**Re: 1306 Girard ST NE (Square 3958, Lots 8 and 9)  
25-Z-PDRM-00065**

We have reviewed the proposed plat and architectural drawings provided, see attached, and have determined the following.

**BZA LOT ADJUSTMENT**  
1306 GIRARD ST NE  
WASHINGTON, DC 20017

Plat for Building Permit of :

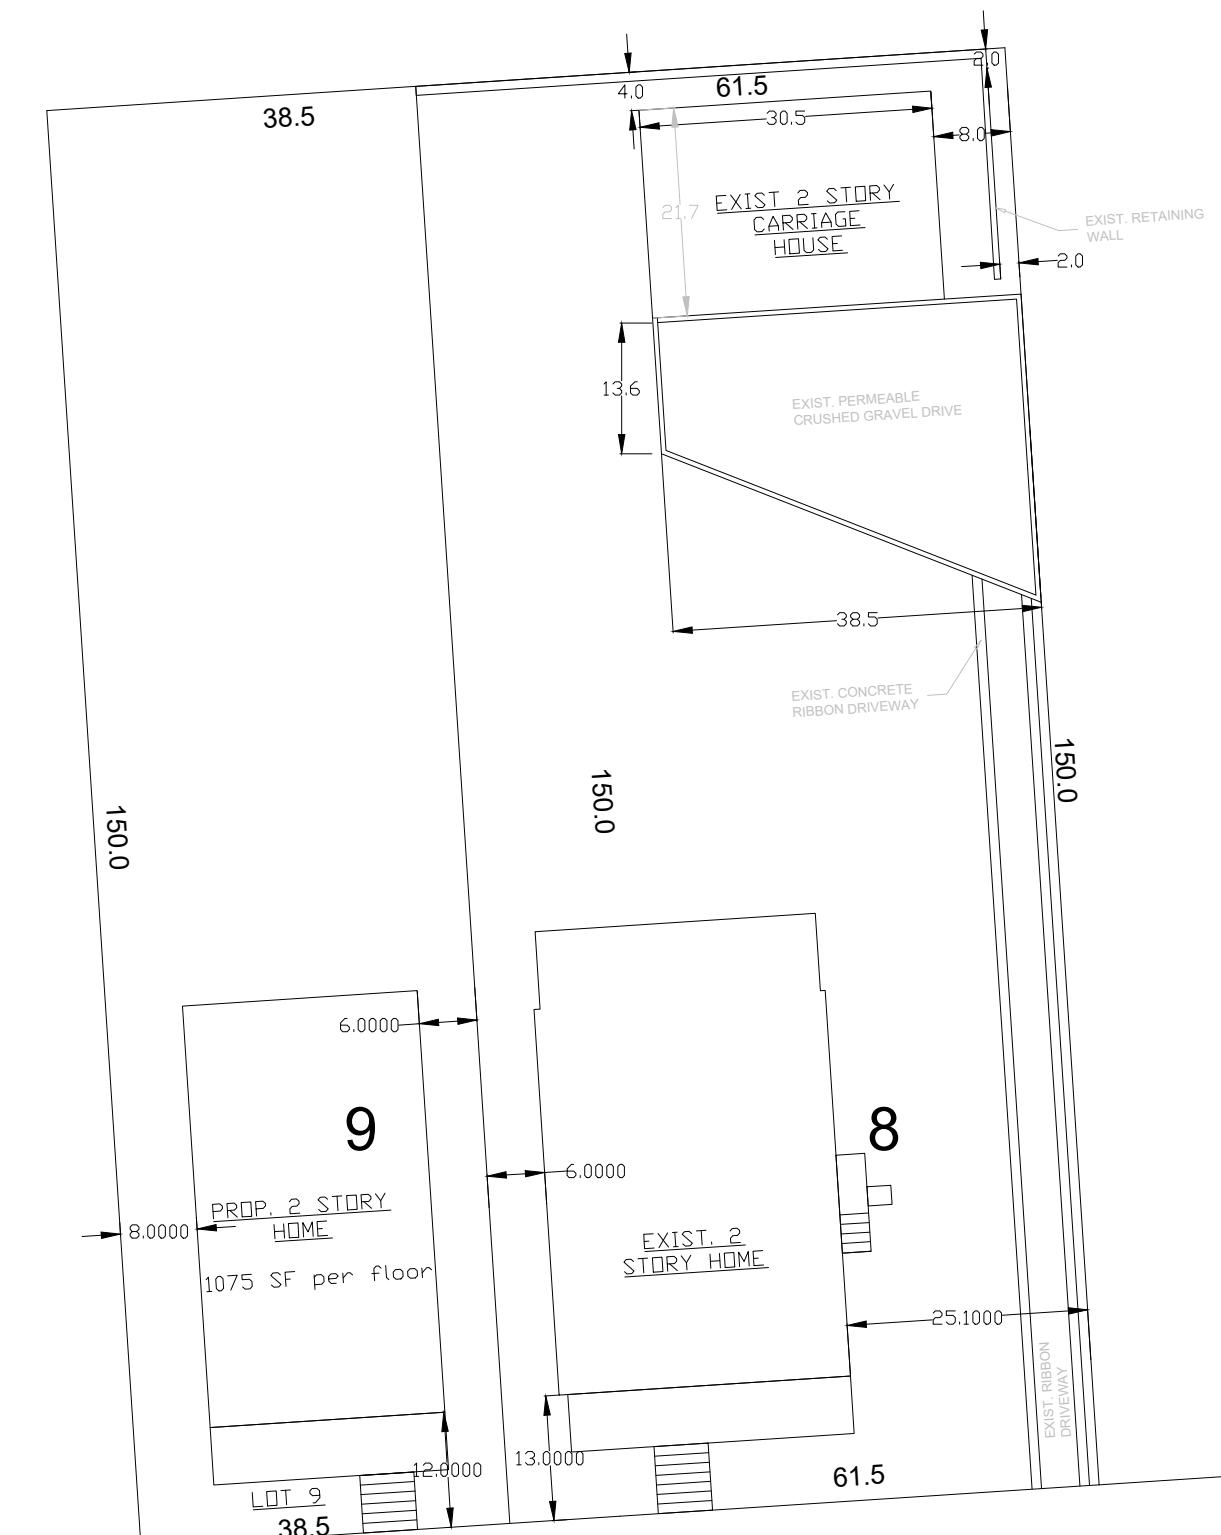
Area Variance relief pursuant to X-1000.1 from the Subdivision regulations in C-302.1 is required because any lots created must conform to the regulations for lot area, width, and yards. Proposed Lot 8 would be nonconforming for side yard and proposed Lot 9 would be nonconforming for lot width and side yard.

Area Variance relief pursuant to X-1000.1 from the Lot Width requirements in D-202.1 is required for Lot 9 because 50 feet of width is required and 38.5 feet of width is proposed.

Area Variance relief pursuant to X-1000.1 from the Side Yard requirement in D-208.2 is required for Lots 8 and 9 because two 8-foot side yards are required and 6-foot side yard is proposed at the west side lot line for Lot 8 and a 6-foot side yard is proposed at the east side lot line for Lot 9.

**A01**  
SHEET 1 OF 3

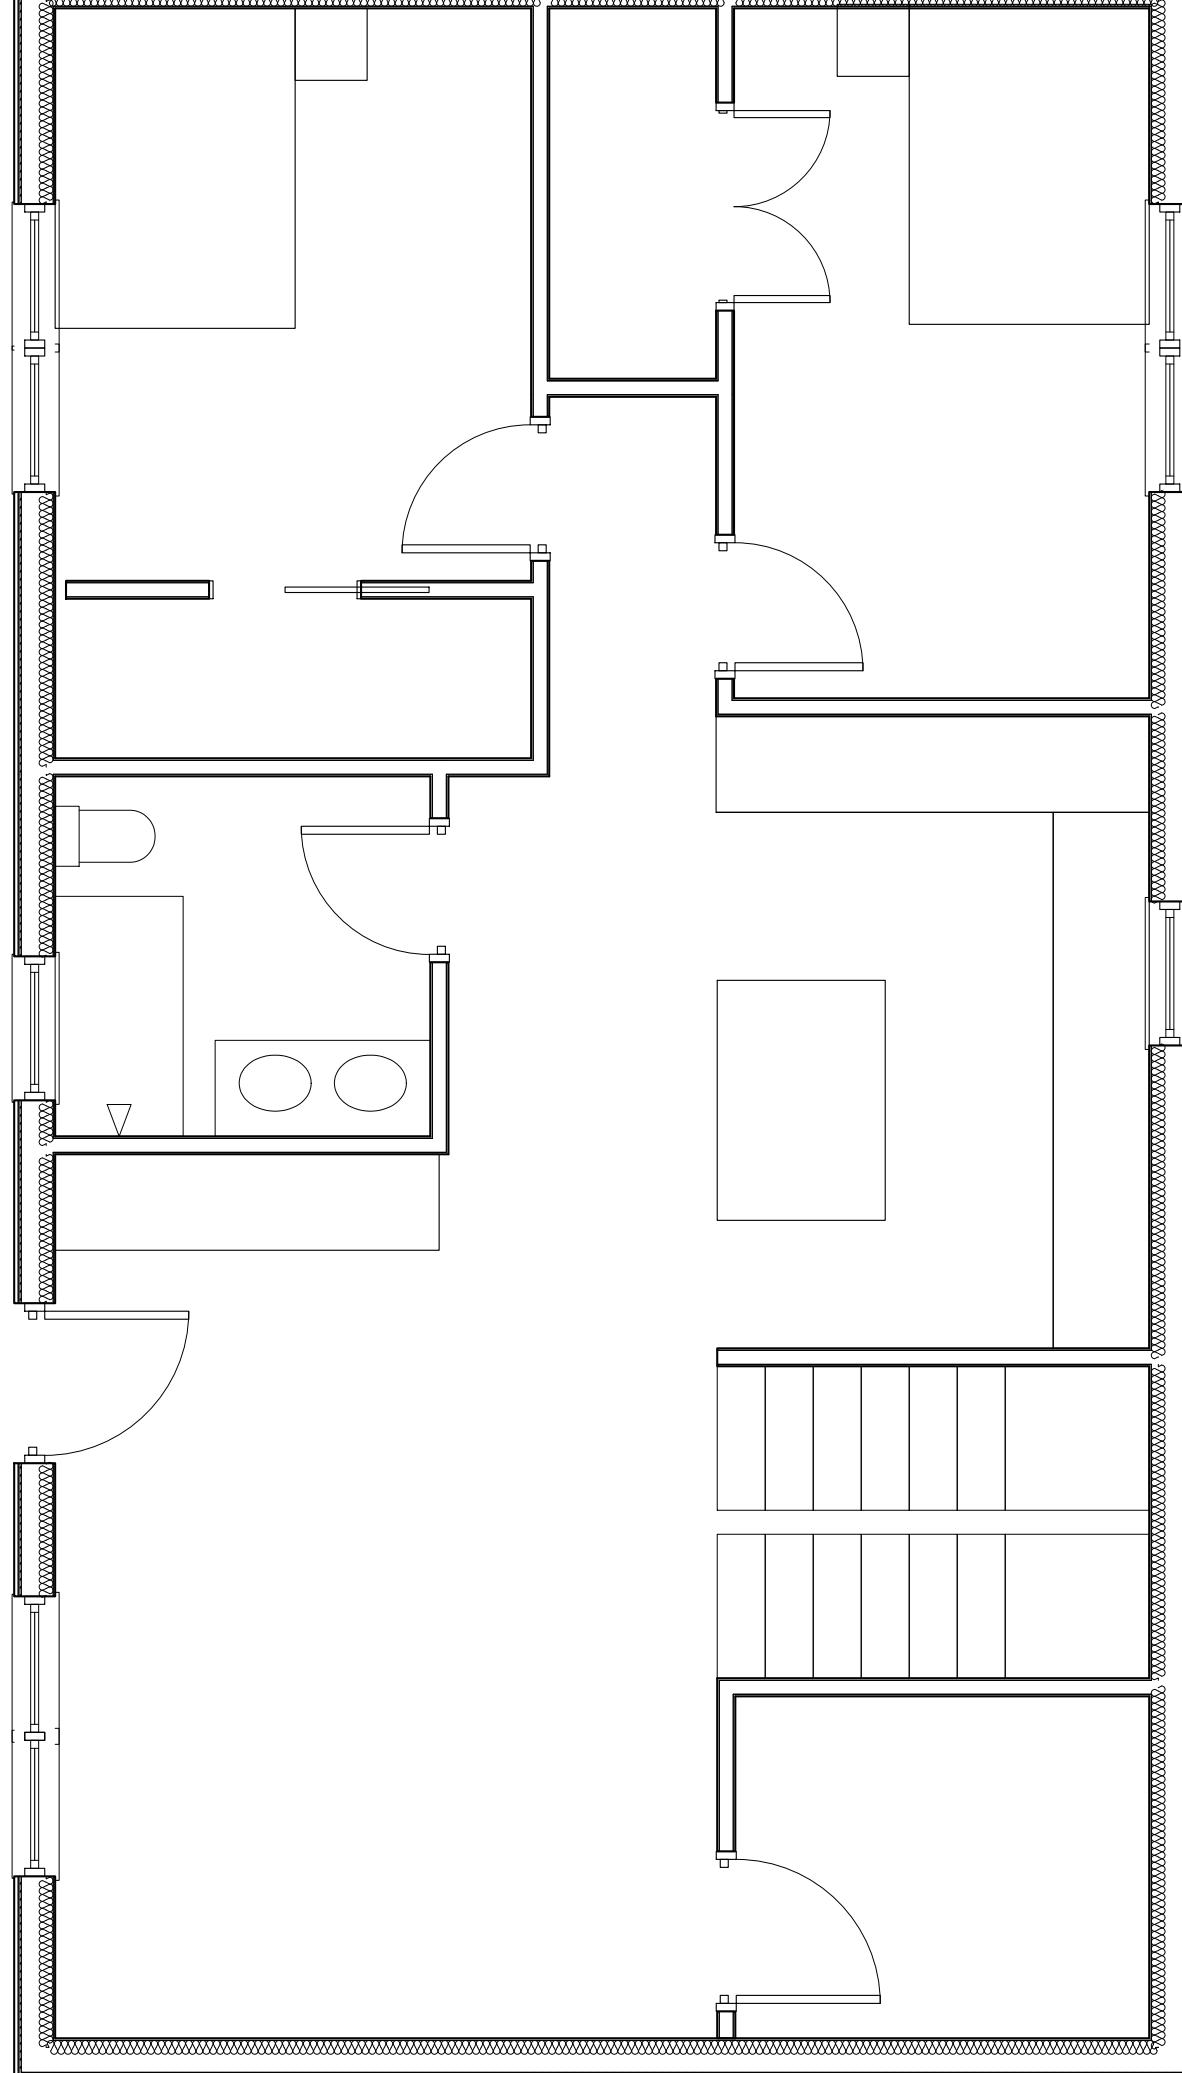
One (1) parking space must be provided for Lot 8 per C-701.10 because the number of required parking spaces, which is 1 per principal dwelling shall not be reduced below the minimum required as long as the use that generated that requirement remains in existence and per C-701.14 because required parking spaces shall be provided and maintained so long as the structure that the parking spaces are designed to serve exists. No parking is required for proposed Lot 9 per C-702.4(a) because the proposed lot does not have access to an open, improved, and public alley with a right of way of 10 feet width minimum.

Area Variance relief pursuant to X-1000.1 from the Accessory Maximum Building Area requirement in D-5003.1 is required because the proposed 661.85 square foot accessory building on Lot 8 exceeds the greater of 30% of the required rear yard (461.25 square feet) or 450 square feet.
